Addendum Number: 02

Addendum Issue Date: April 22, 2025

Project Name: Robinson Washington Elementary

Renovation & Addition

GENERAL INFORMATION

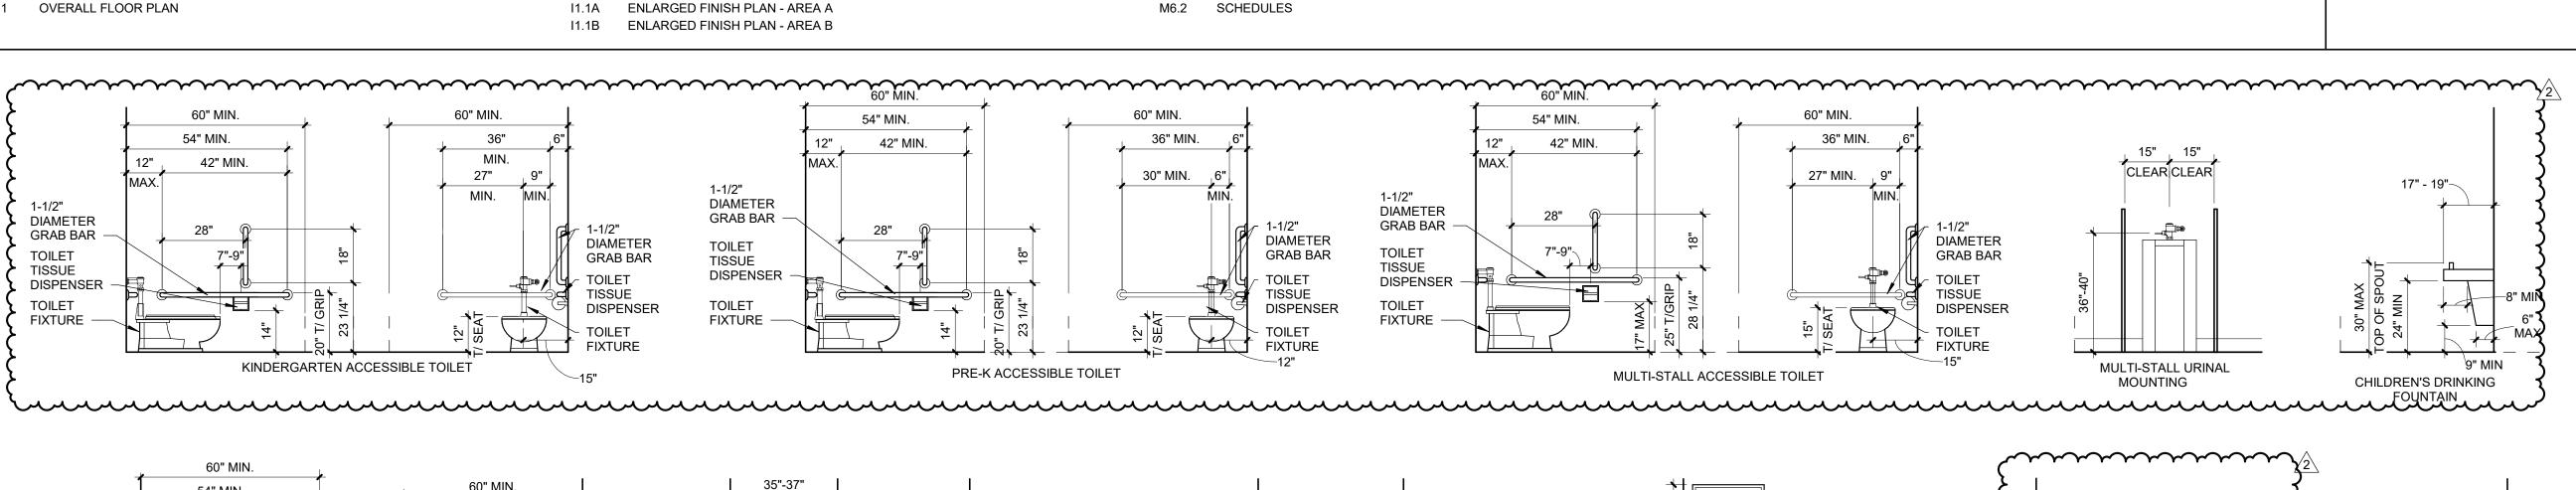
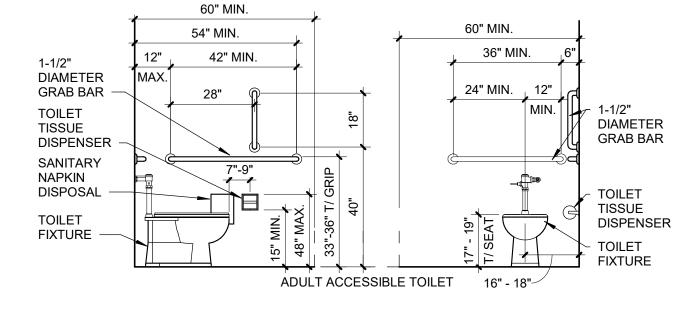
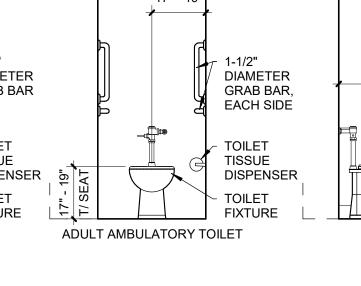
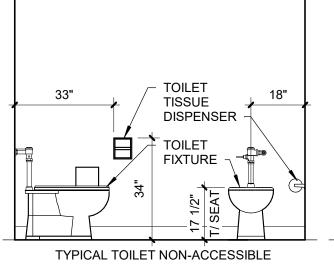
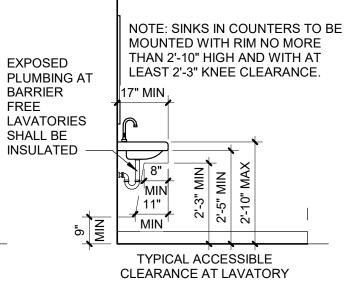
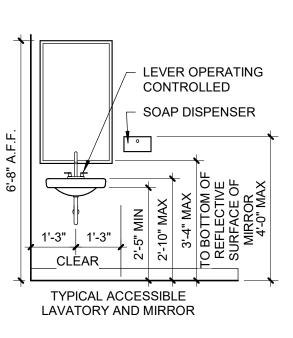
- 1. G0.1 GENERAL INFORMATION
 - a. REVISE children's plumbing fixture mounting heights to reflect accessibility code as shown, including kindergarten, pre-k, and multi-stall toilets. See attached.
 - b. REVISE urinal mounting to reflect urinal type and dimensions shown in multi-user restroom T111. See attached.
- 2. LS1.1 FIRST FLOOR LIFE SAFETY PLAN
 - a. REVISE plumbing fixture calculation to be for 279 m/f occupants. See attached.
 - b. REVISE plumbing code review note to read, "THE OCCUPANT LOAD AND THE REQUIRED FIXTURE COUNT ARE BASED UPON THE SCHOOL (ELEMENTARY) USE GROUP AND ARE DETERMINED AS PER ILLINOIS PLUMBING CODE" See attached.
- 3. AD1.1 DEMOLITION PLANS
 - a. REVISE dimensions of new opening in existing cmu wall as shown in partial demolition floor plan. See attached.

A7.3.1

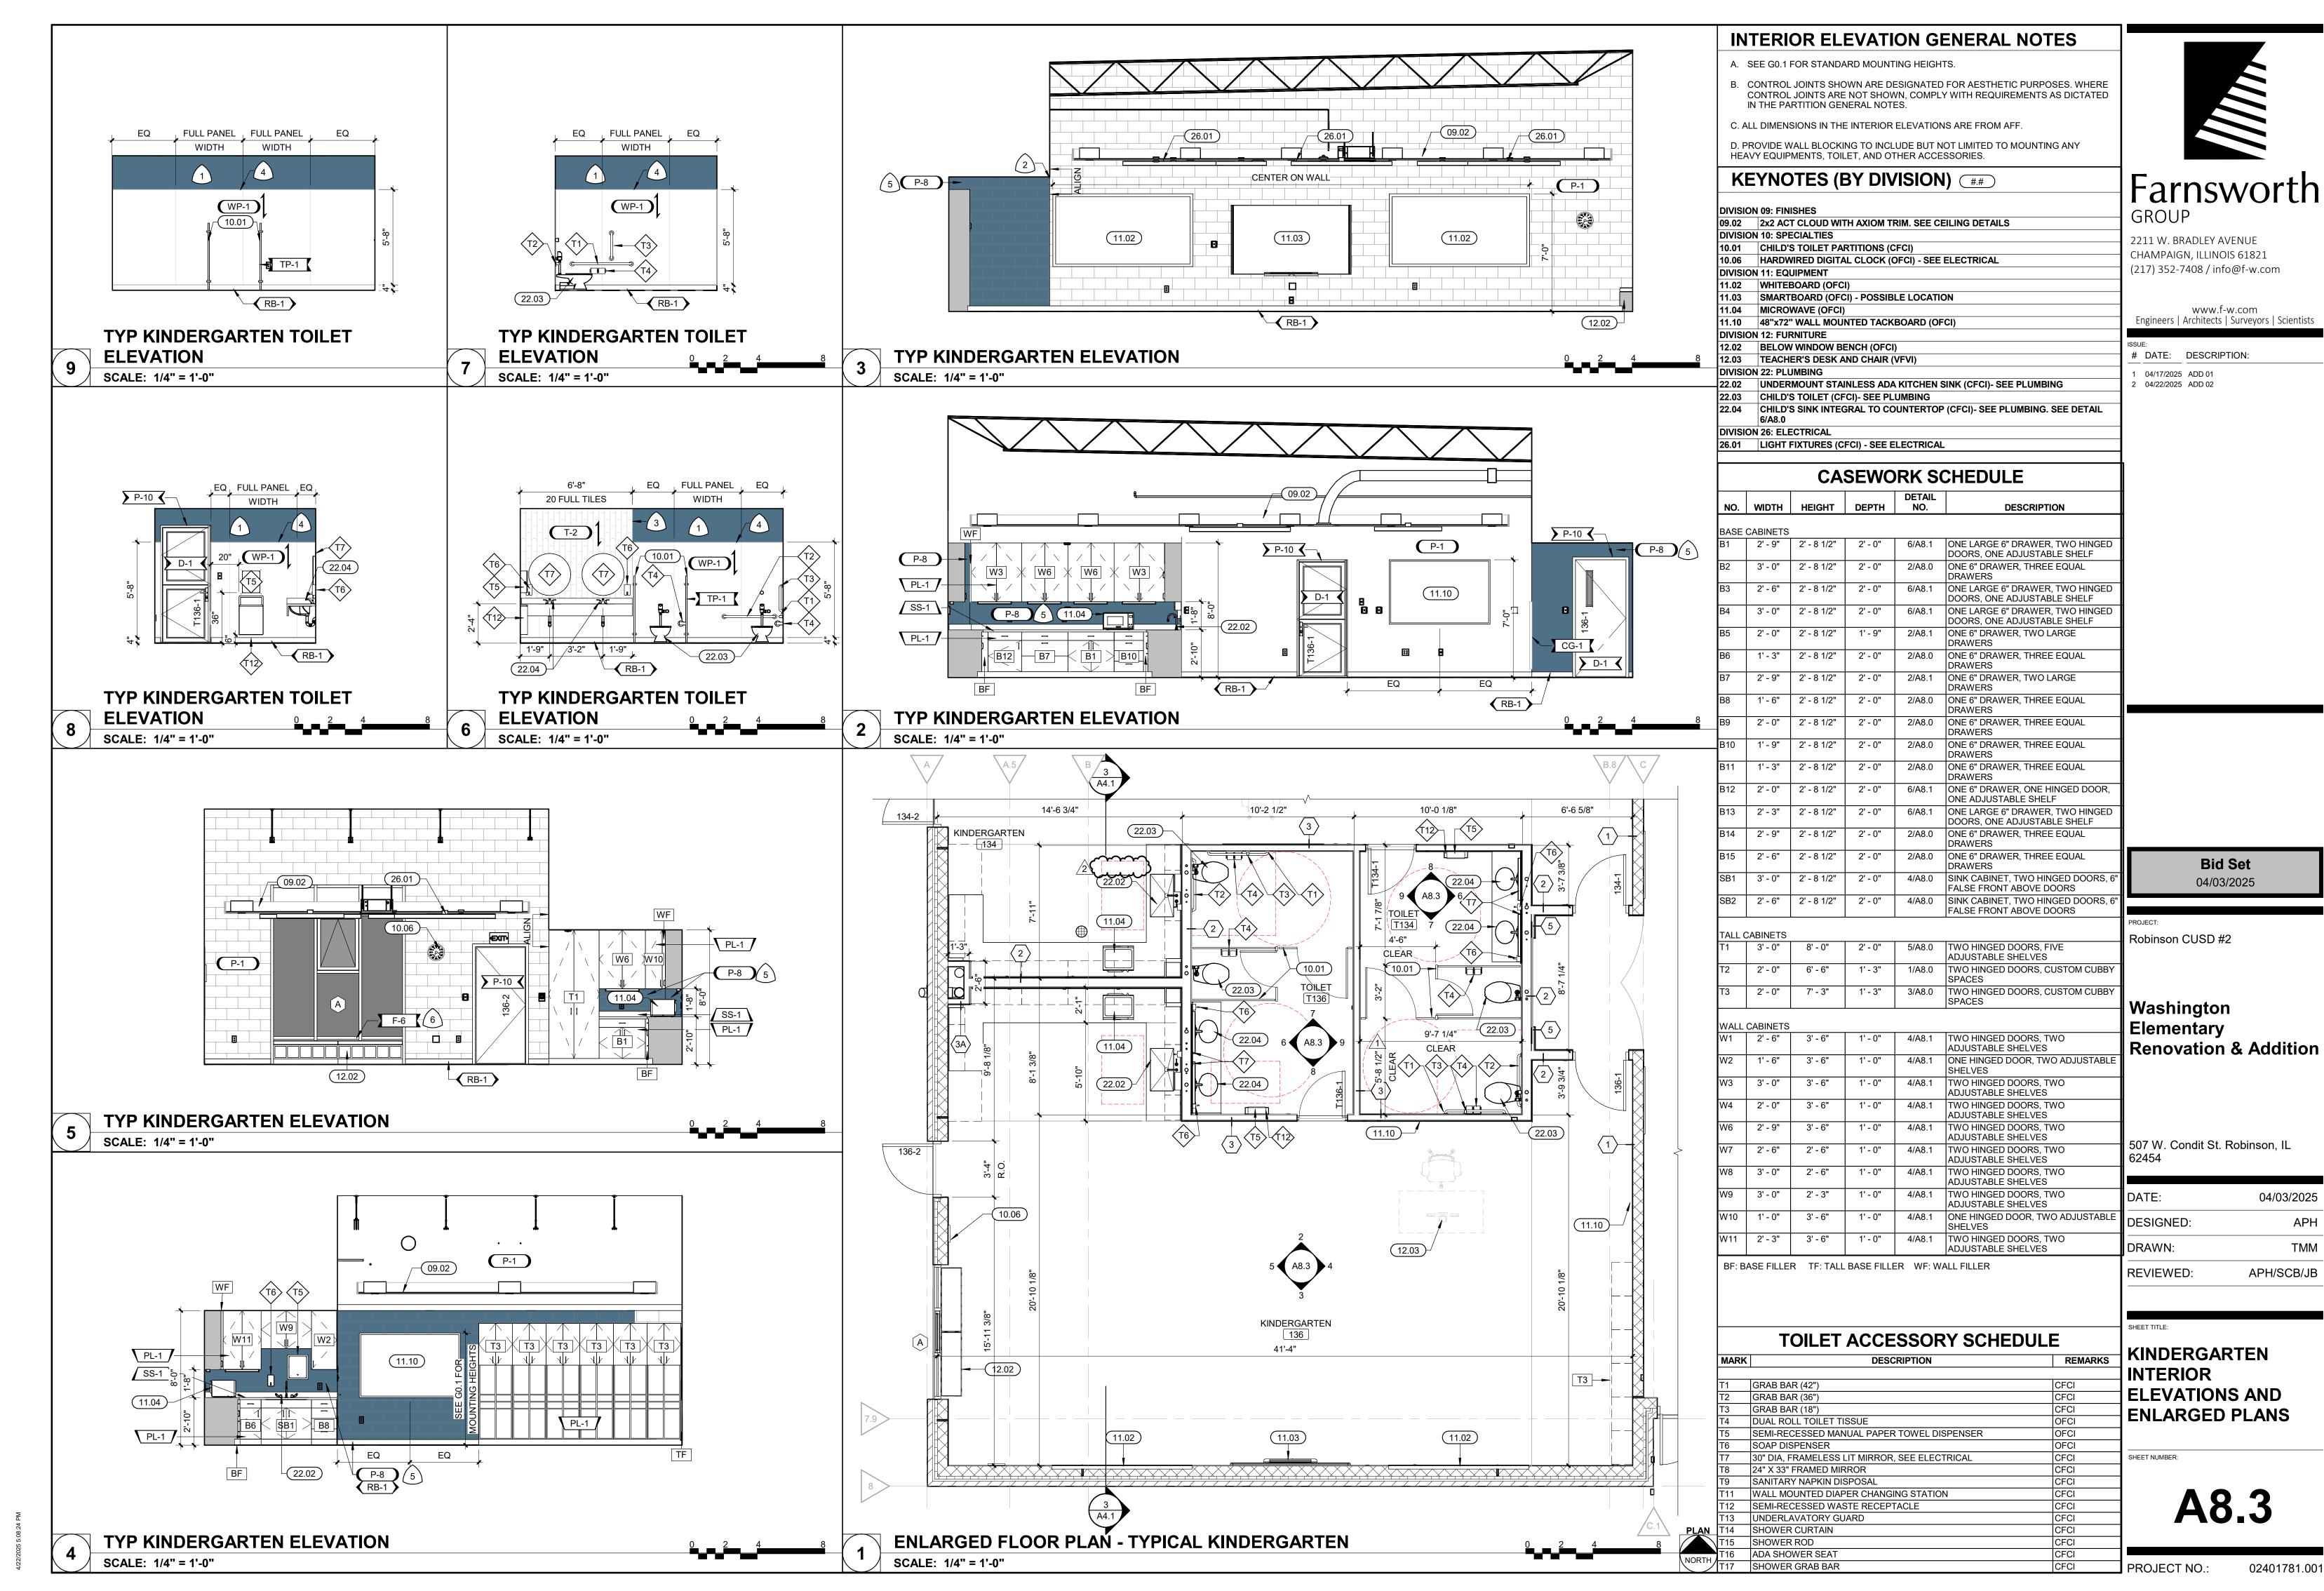
- a. ADD note to read, "ALL GLAZING MARKED AS IG-1, TO HAVE PRIVACY FILM APPLIED, SEE A7.3. ALL GLAZING CONTAINING PRIVACY FILM NOT SHOWN ON THIS SHEET IS TO BE OF A SOLID COLOR SELECTED BY ARCHITECT AND OWNER. THIS SHEET IS ONLY TO SHOW DESIGN INTENT FOR PRIVACY FILM CONTAINING ADDITIONAL GRAPHICS AND BRANDING." See attached.
- b. ADD title to glazing elevation A to clarify that all classroom windows (glazing type A) are to receive the same graphics. See attached.
- c. ADD additional window type D to WEST ELEVATION AREA B GRAPHICS. See attached.

ENLARGED FINISH PLAN - AREA A

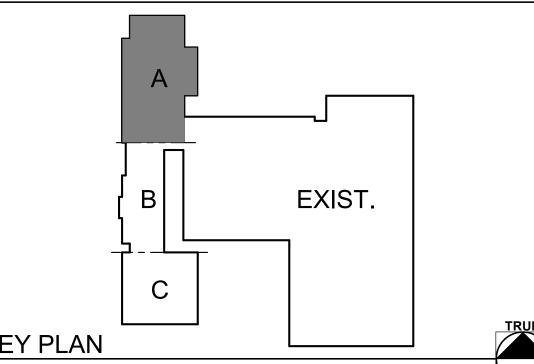
a. REVISE detail #1 as shown.

ENLARGED FINISH PLAN - AREA C

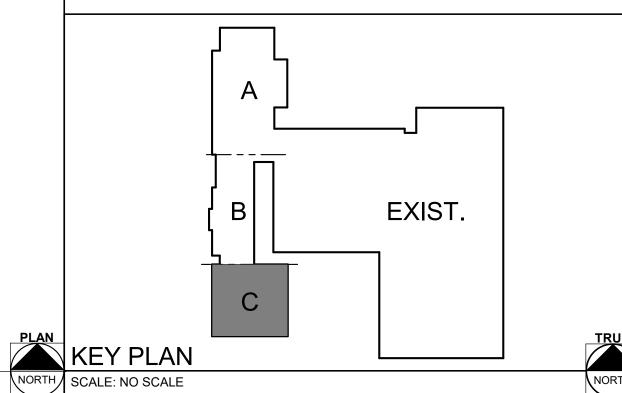
a. REVISE detail #1 as shown.
